Angolo Ristorante
2934 M St NW
Washington, DC 20007

ATTN: Old Georgetown Board

Regarding the city's request for additional information regarding the above-mentioned project, we have prepared the following revisions for final approval:

ELECTRICAL

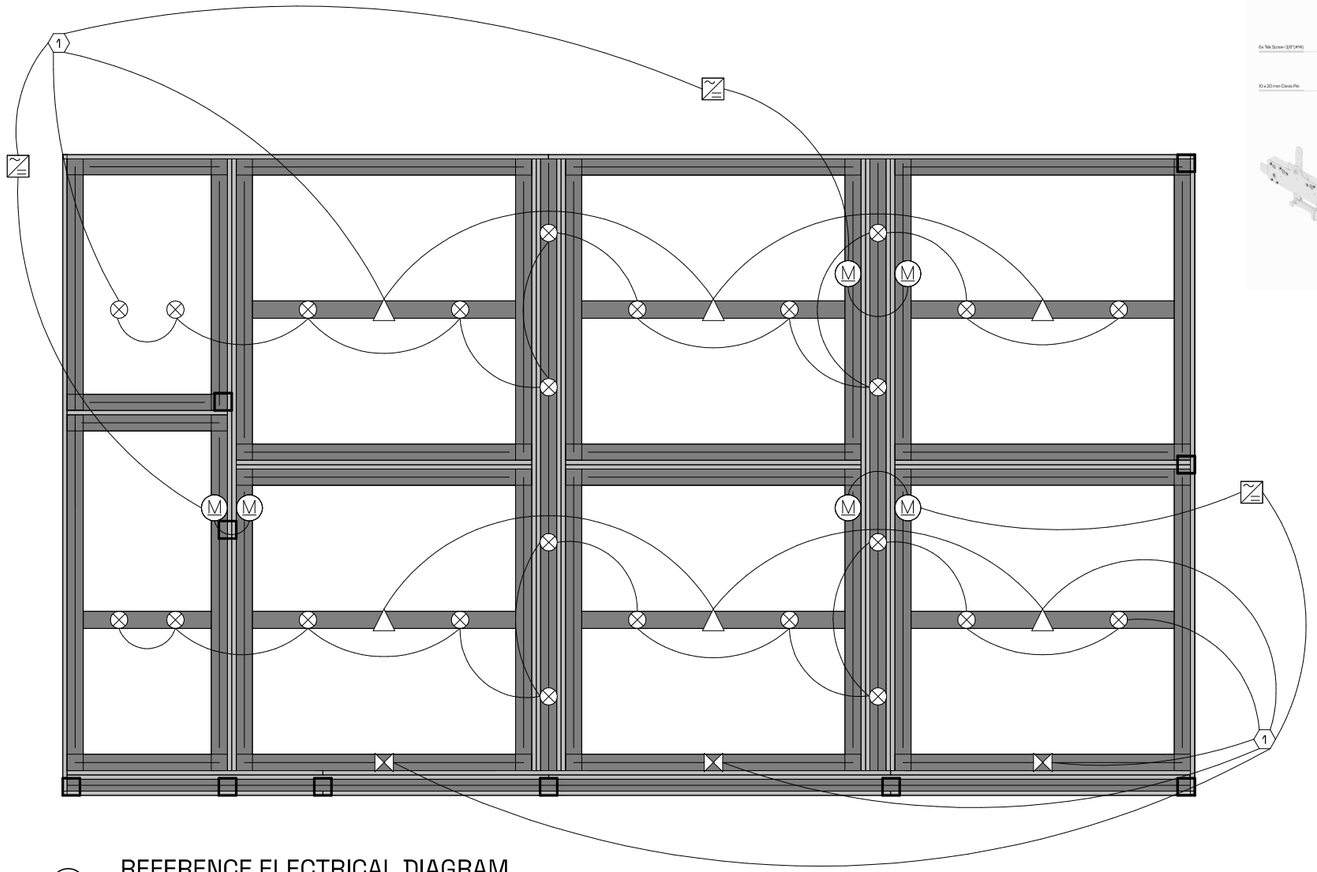
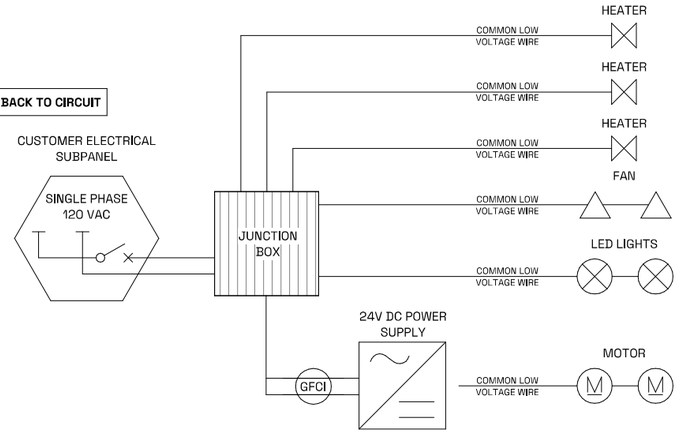
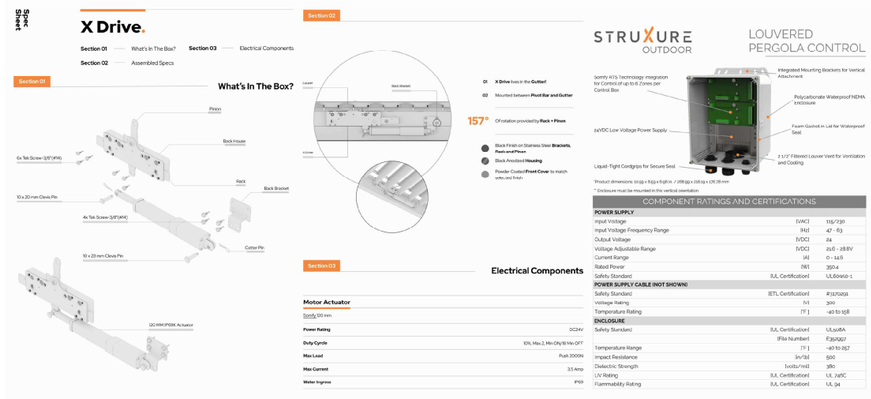
10. What type of lighting would be used? Please include details for the fixtures.

Response: HLB4 4in Slim Canless LED Downlight Specs are the lights to be used. The legend has been updated to include this lighting type on E001.

POST FRAMING PLAN

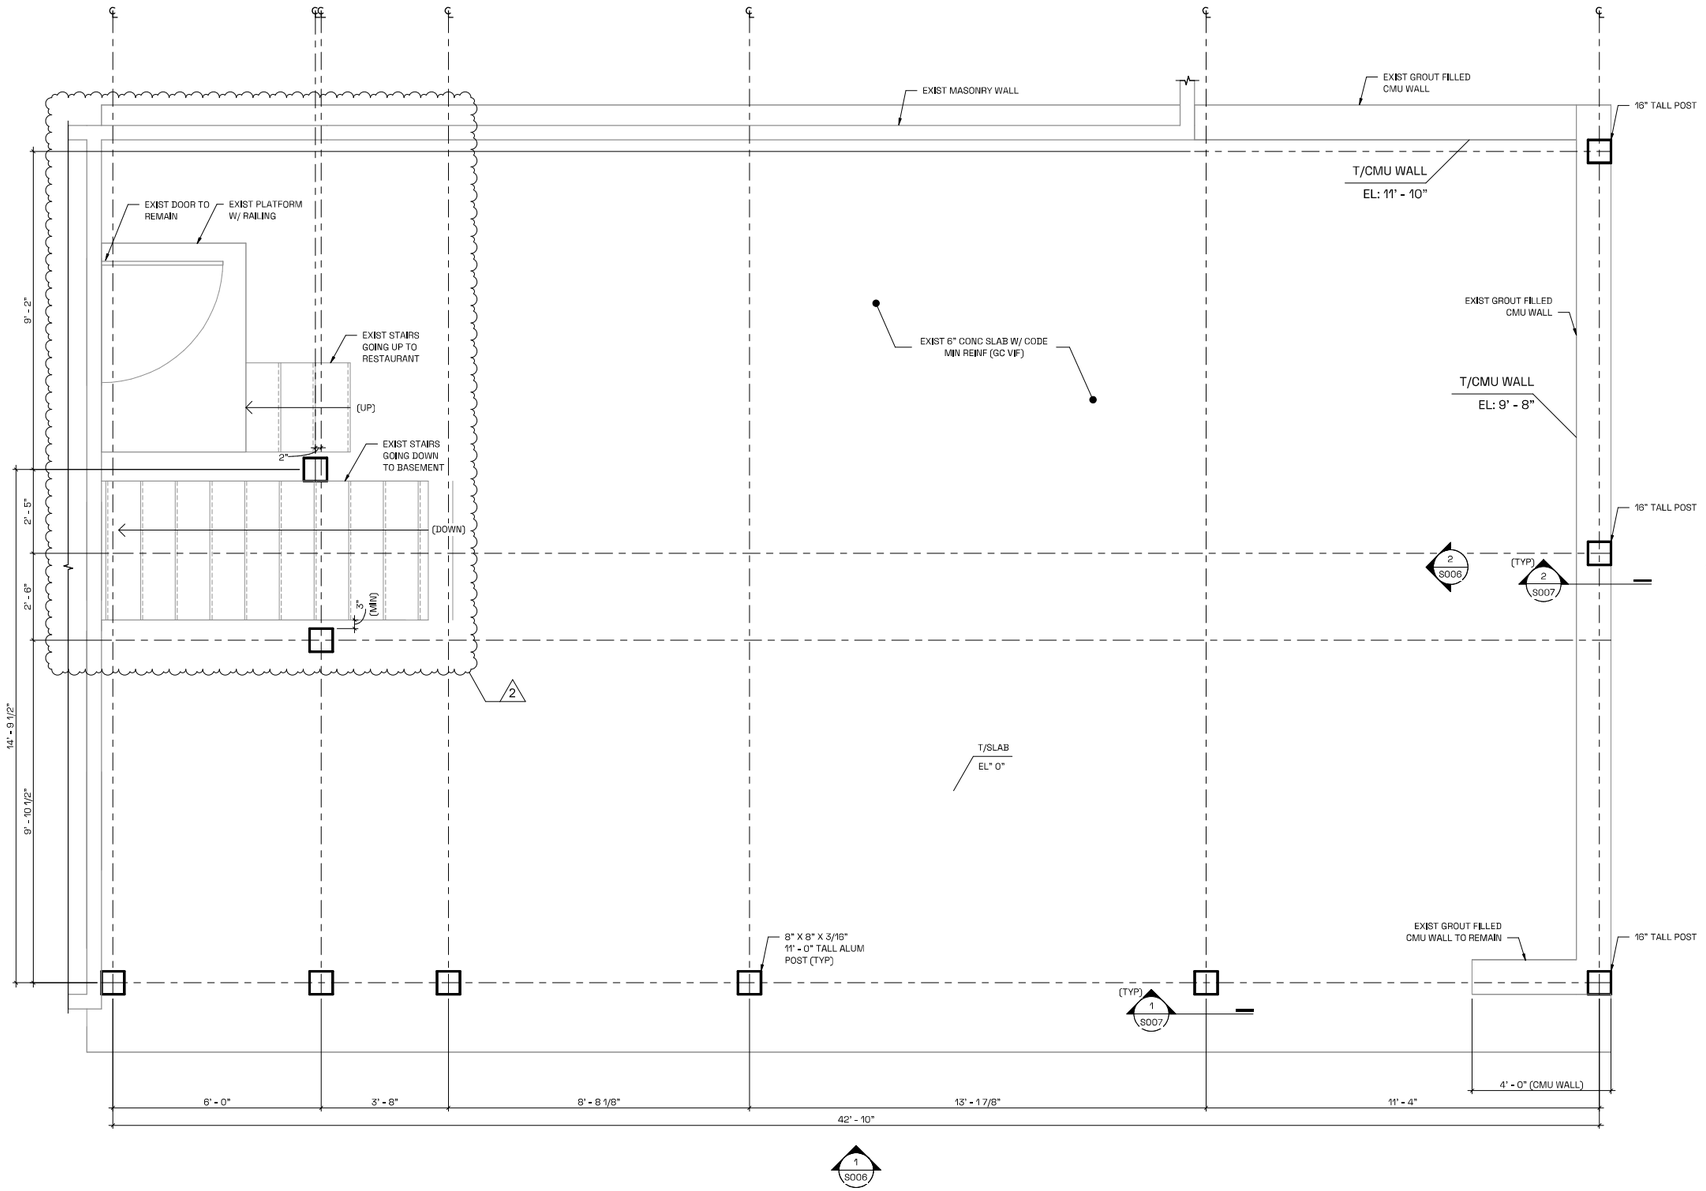
5. A short wall extends across the 30th Street property line. Would that be retained? Please include information in the drawings to clarify.

Response: The wall will be retained, as noted on the revised sheet S003.

1 FRONT ELEVATION

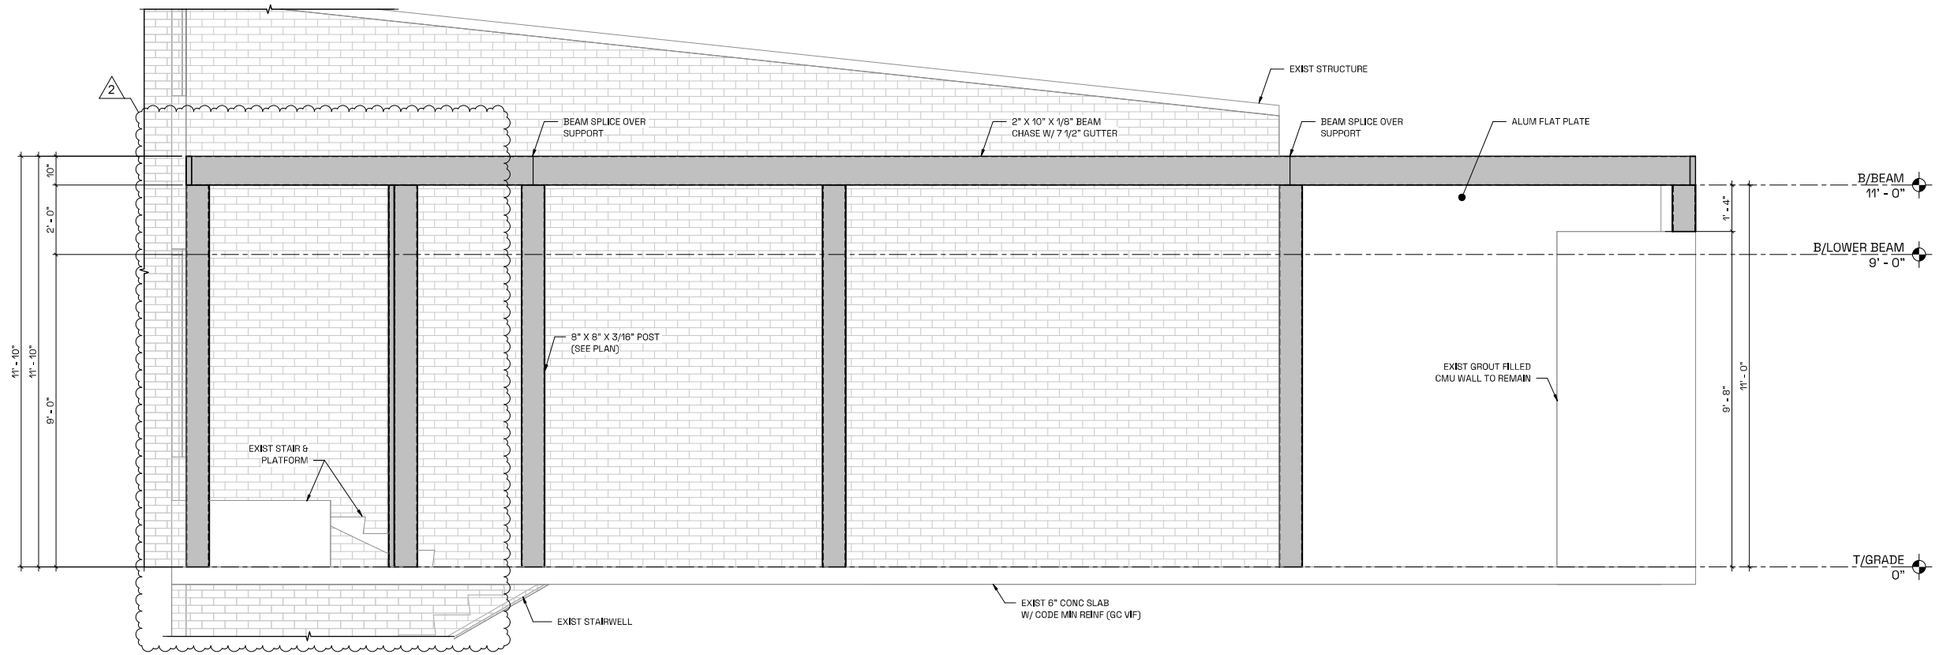
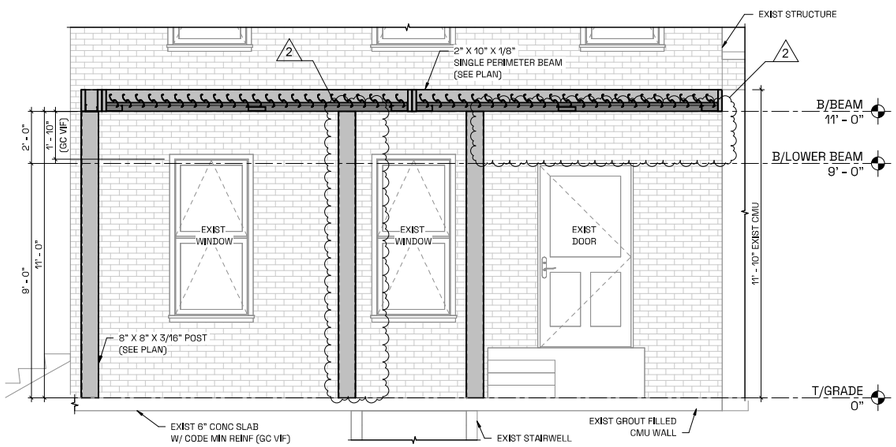
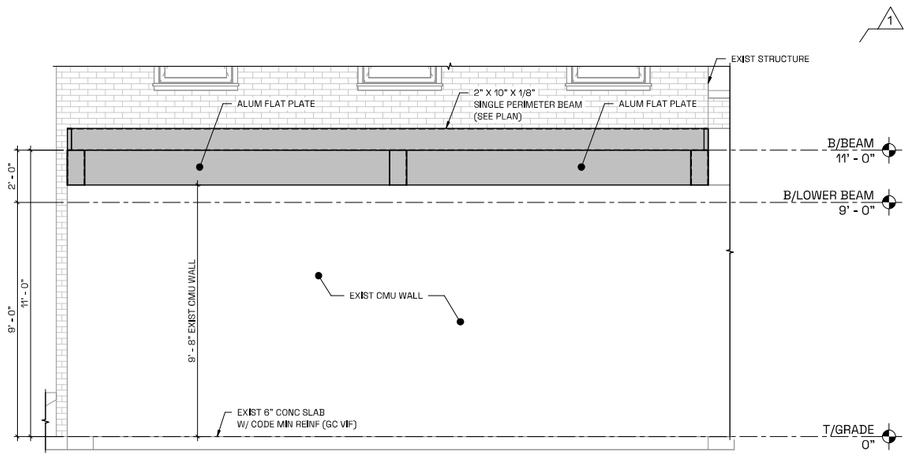
8. Are you proposing to retain the existing vent and other equipment? If so, that needs to be included in the documentation. If not, then the documentation needs to clarify that it will be removed. Note that it was never reviewed or approved, so it must be part of the discussion.

Response: Please see the added note on the Front Elevation that the existing equipment and supporting platform shall remain.

3. Please include the main building in the elevation drawings. We need to understand the relationship between the proposed pergola and the building and windows. Make sure detailed dimensions are included.

4. Please include the existing CMU walls in the elevation drawings. Please make sure they're accurately drawn.

7. Please include detailed dimensions on elevations. We need to understand the relationship between the proposed pergola, the CMU walls, and the main building.

Response: Added detailed dimensions and the existing building for the elevations.

Response: The existing CMU walls are included in the elevation drawings and accurately drawn.

Response: Detailed dimensions included in elevations and plan views.

ALUM SHEET CONNECTION

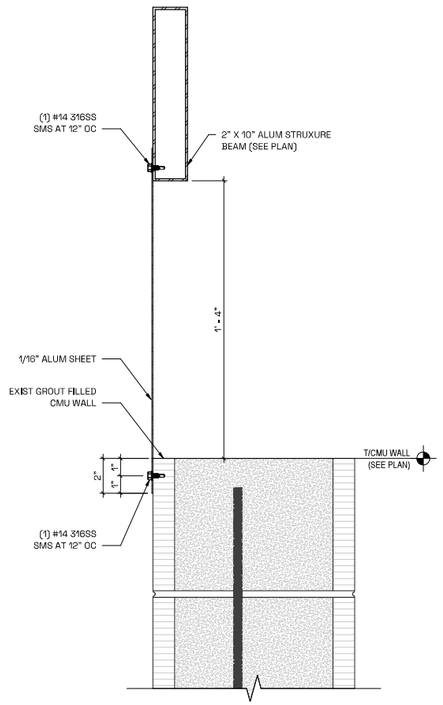
9. Would any covering be added to the top of the pergola? Or would the louvers be the only coverage? It seems some of the "zones" have different coverage, perhaps a metal sheet? Please clarify the documentation.

Response: Zone 1 is the existing equipment support platform, which will remain but be wrapped in new aluminum sheets per detail 6/S008. Zone 2 are "pan louvers" meaning they do not open or close, there is no motor. Zones 3-8 have a motorized function and can open with the push of a button.
